SUBJECT: Addendum No. 4

REFERENCE: Invitation To Bid (ITB) for the IAH Runway 9-27 Grind and Groove at George Bush Intercontinental Airport (IAH); Solicitation No. H06-IAHRWY-2025-009; Project No. 1073

IAH Runway 9-27 Grind and Groove at George Bush Intercontinental Airport

GEORGE BUSH INTERCONTINENTAL AIRPORT (IAH)
RUNWAY 9-27 GRIND & GROOVE
 PAVEMENT DETAILS SHEET 04 OF 04

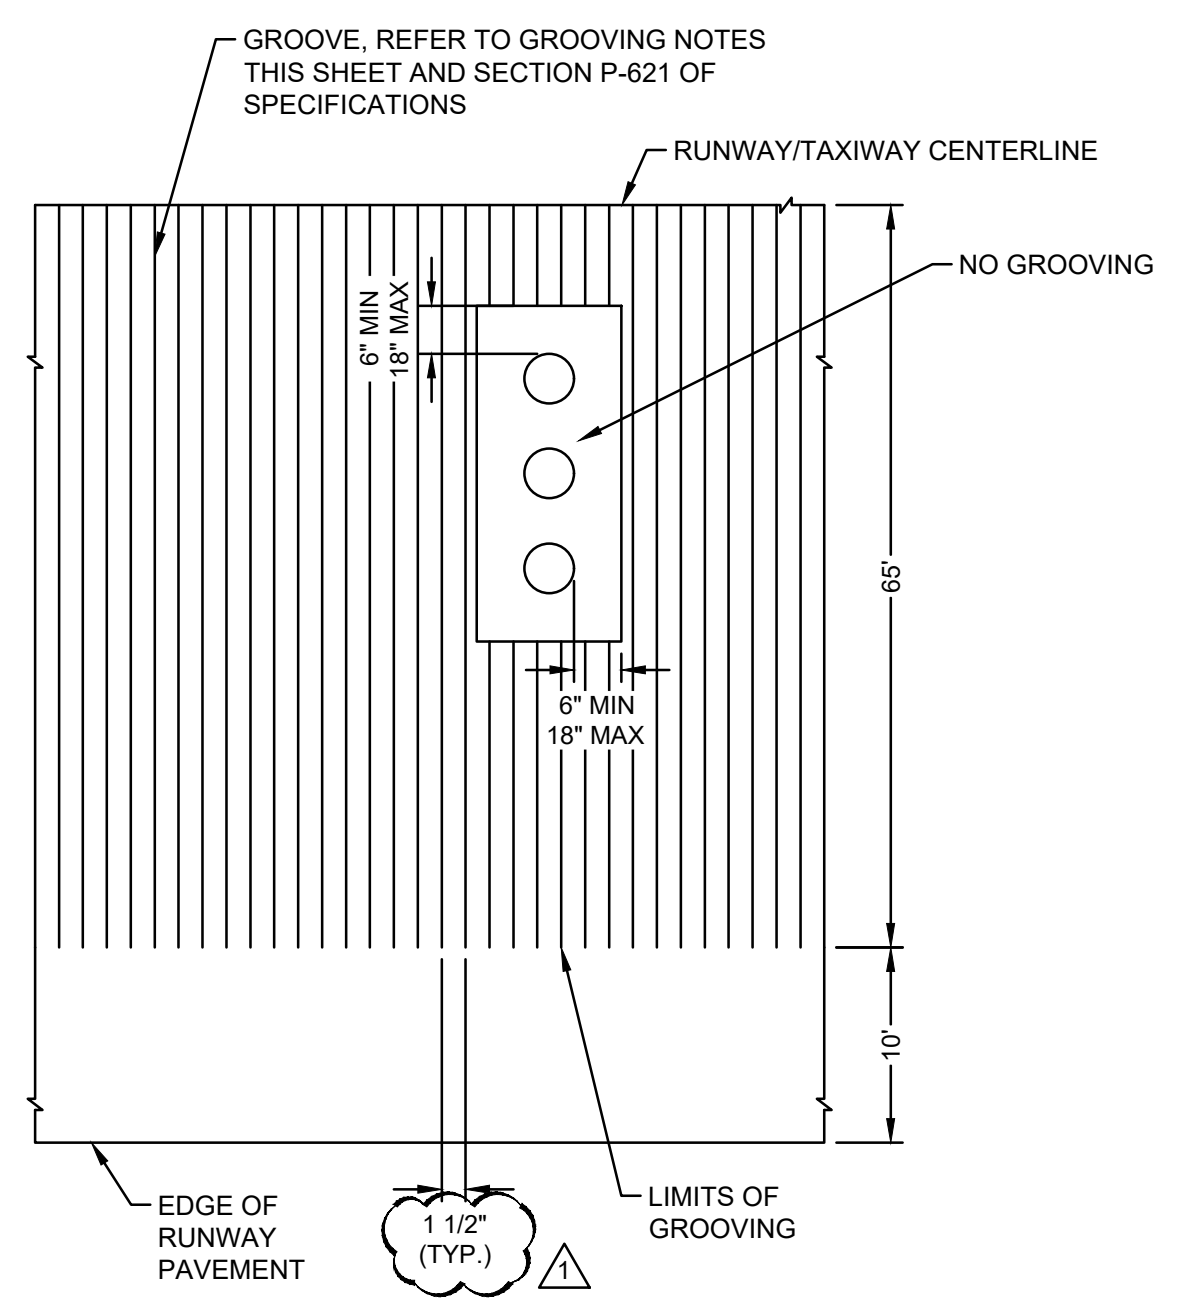
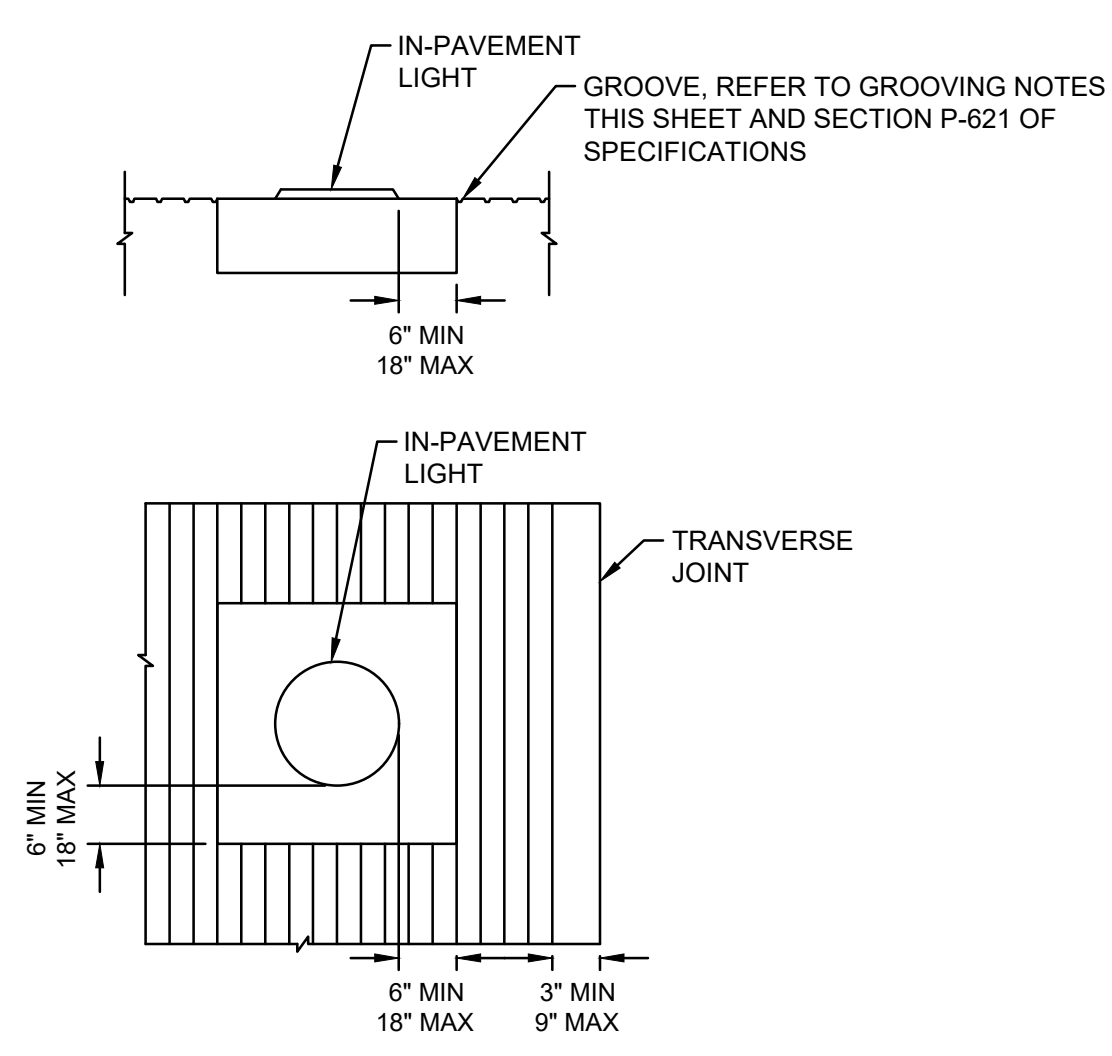
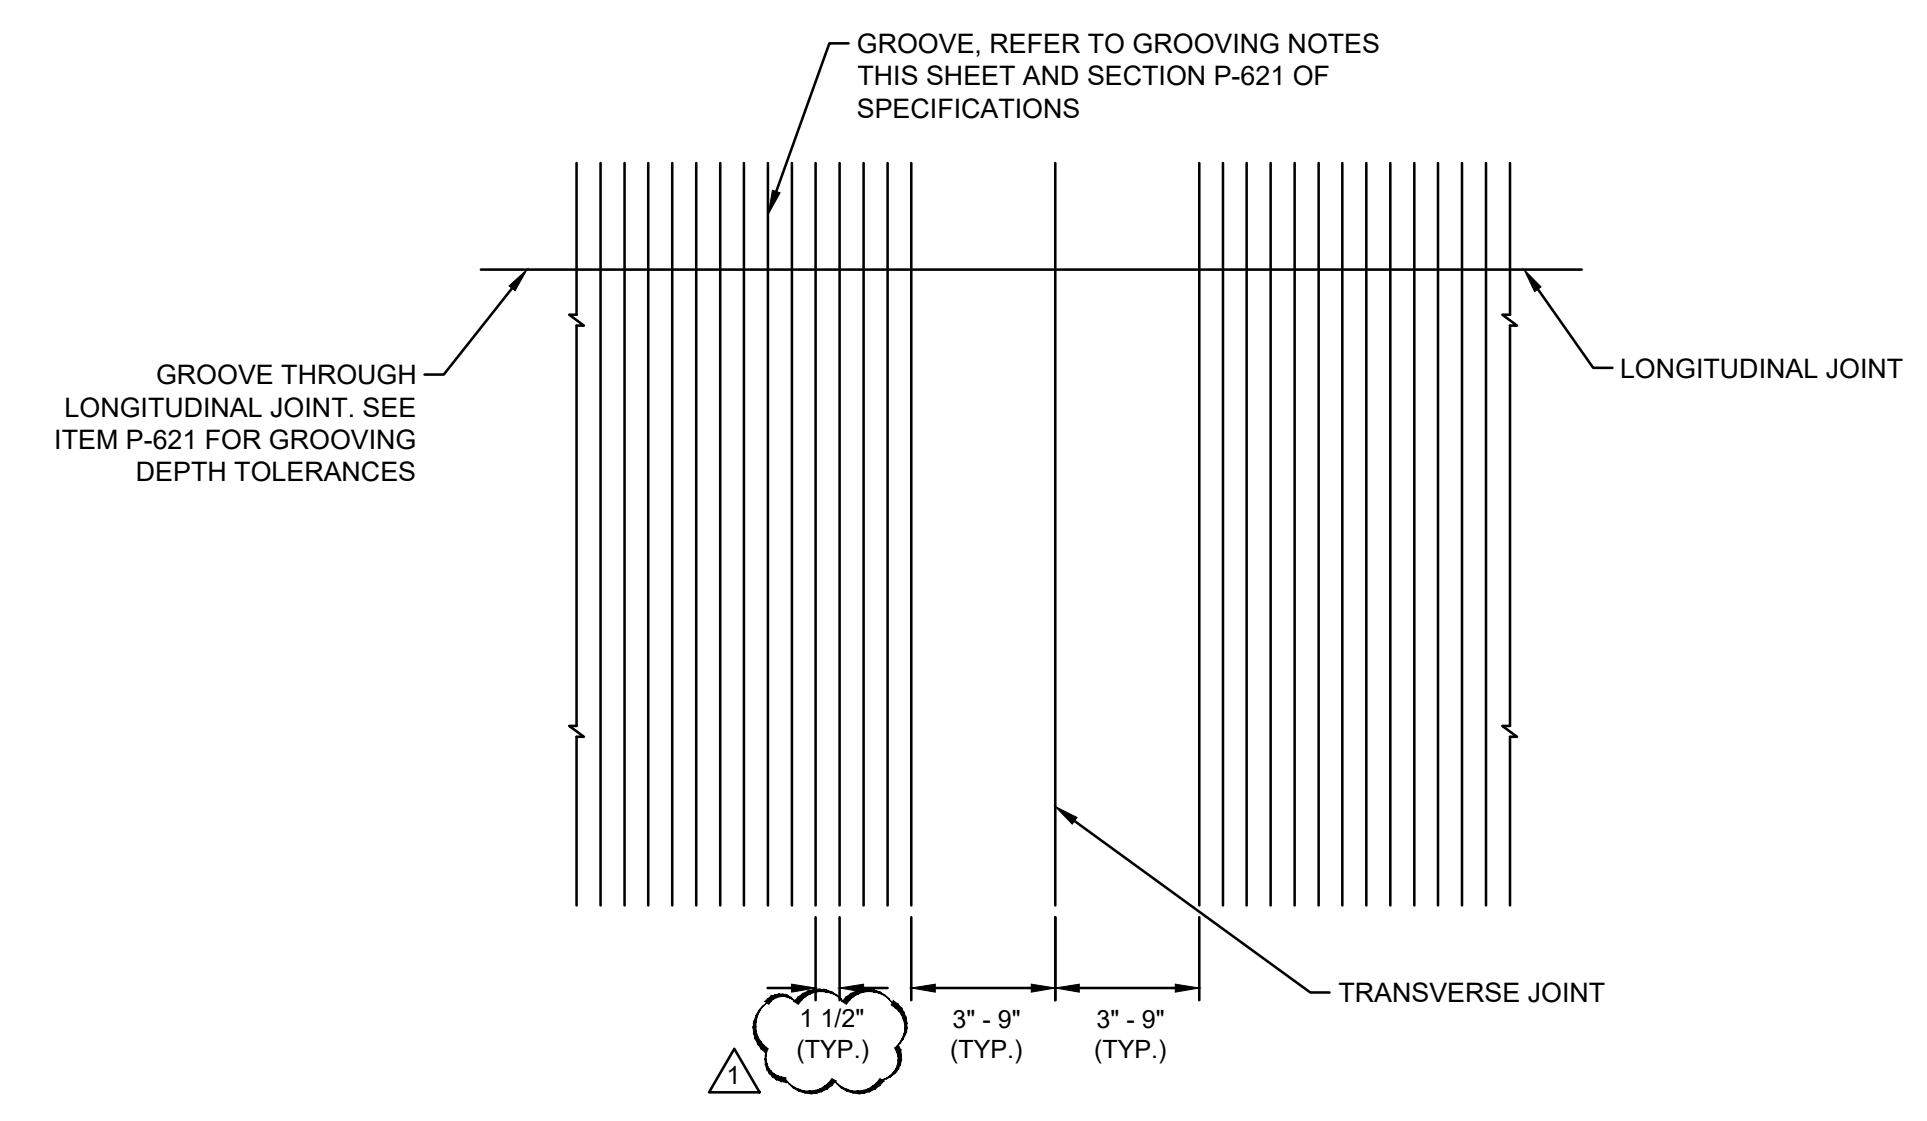
14. **Question:** Can HAS please review the runway grooving quantity? The quantity should not include the outer 10' on each side of the runway.

Response: See attached G-002 and Document 00410 for quantity updates. See attached CP series for the legend update for clarification. See attached sheet CR-504 for the grooving detail updates.

GEORGE BUSH INTERCONTINENTAL AIRPORT (IAH)
RUNWAY 9-27 GRIND & GROOVE
TEMPORARY ELECTRICAL PROVISIONS

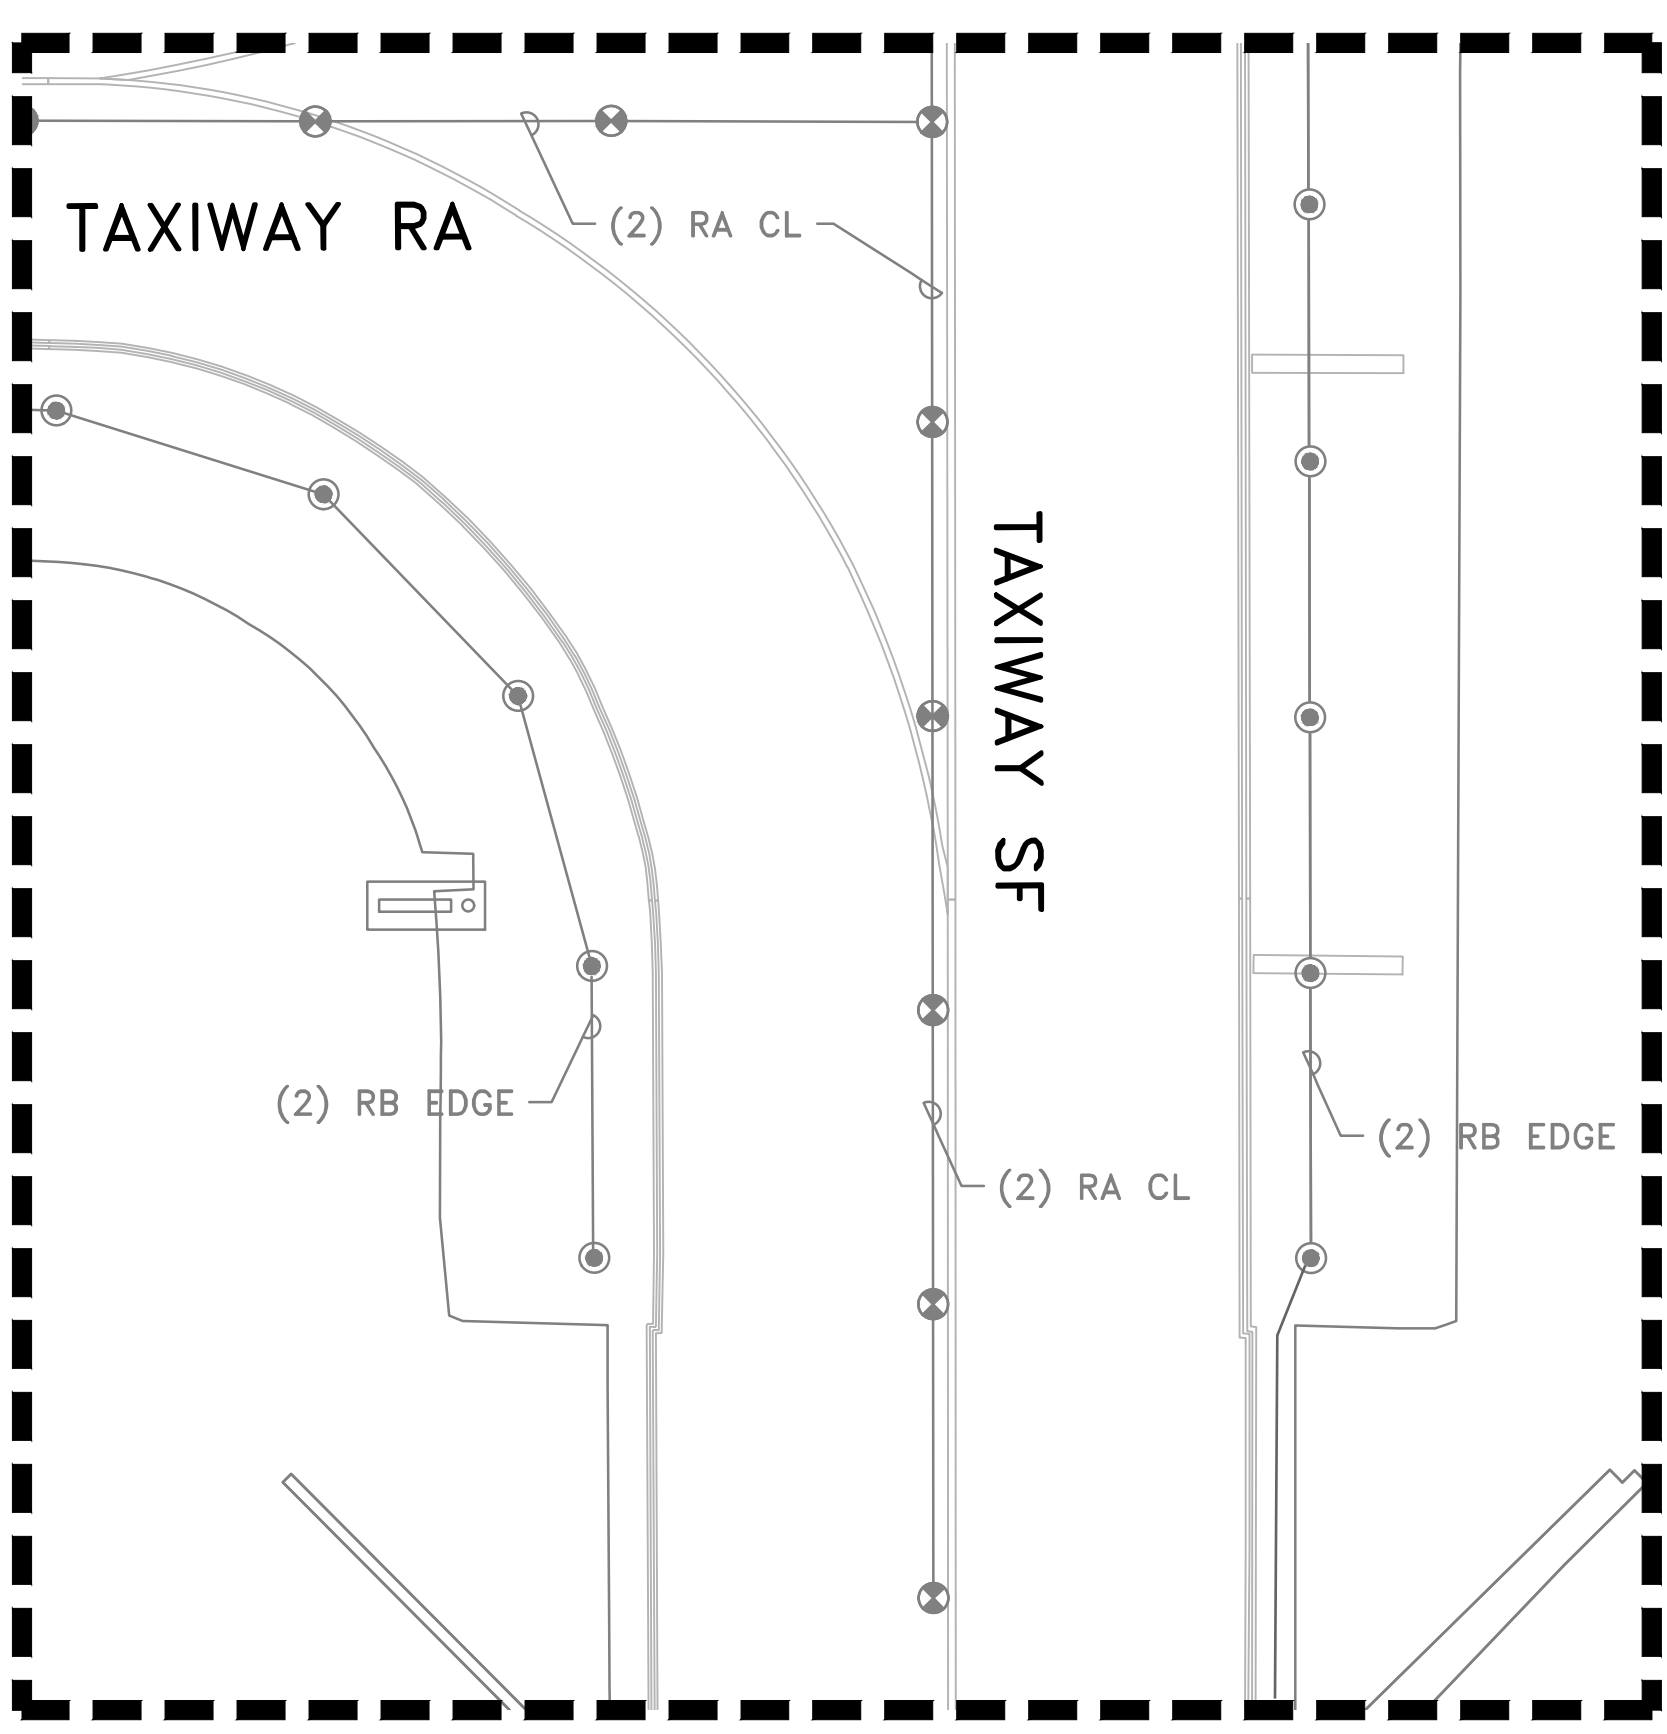
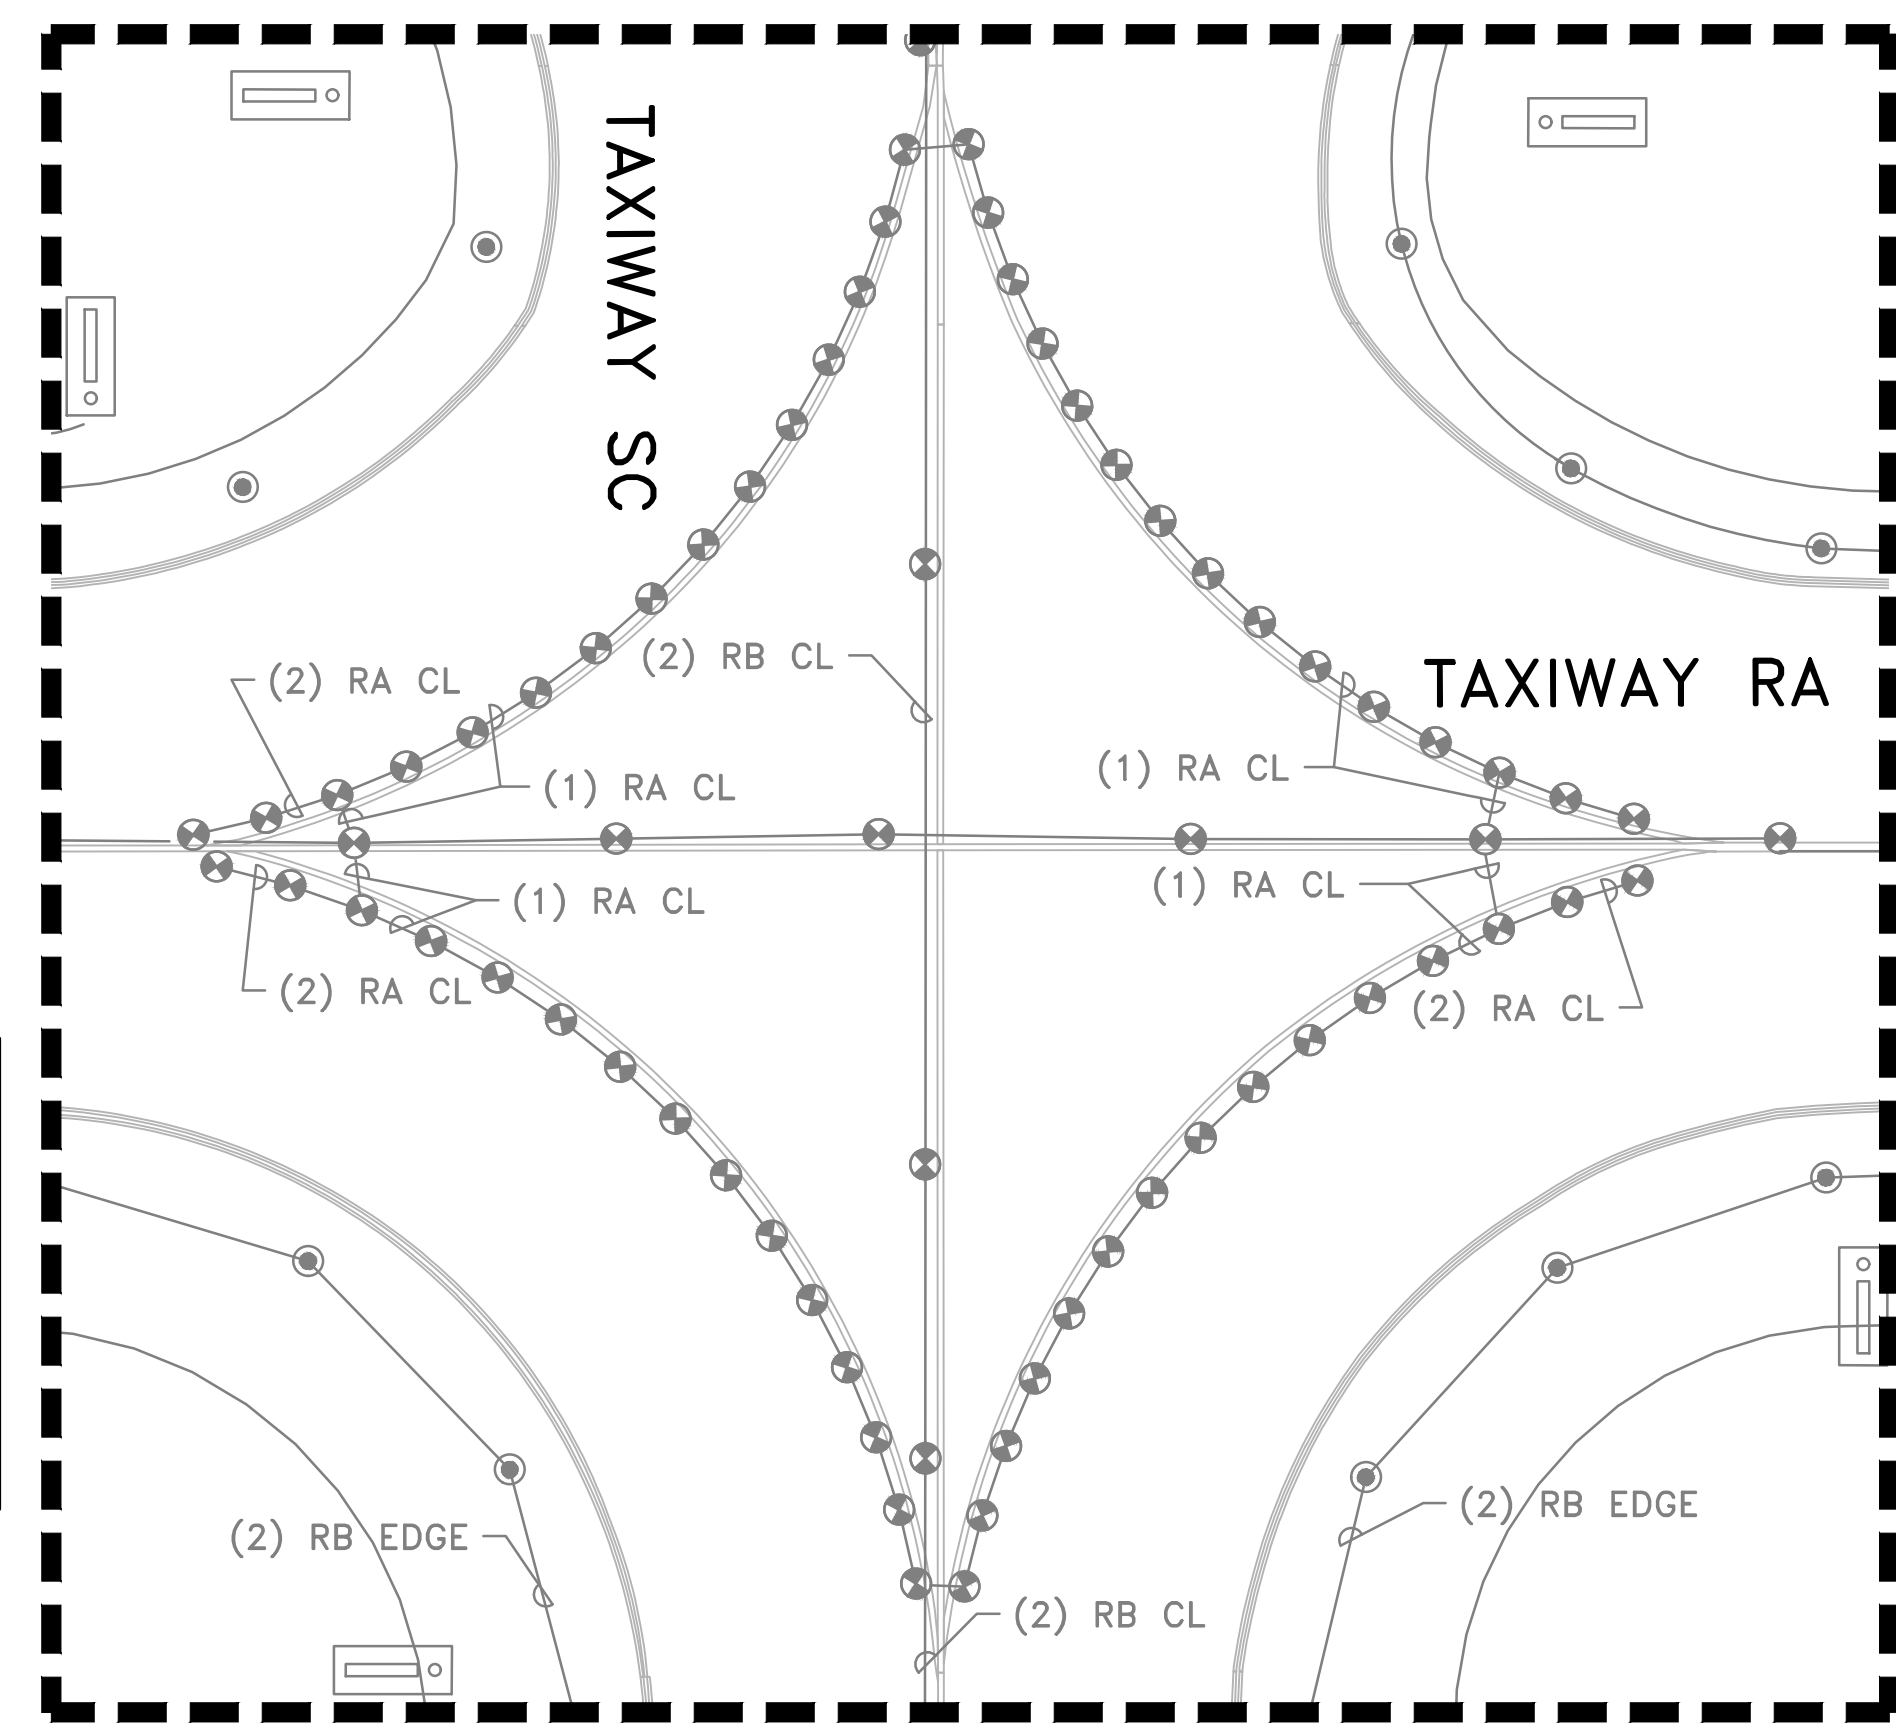
3. **Question:** Reference Bid Form Item No. 24: In order to correctly price the Temporary Electrical Provisions, can the engineer provide circuitry information for the South Complex taxiways including T/W RA & T/W RB at the intersections with T/W SC & T/W SF?

Response: See plan sheet EP-101 included in Addendum No. 3 for additional circuiting information. See Document 00015 for the updated List of Drawings.
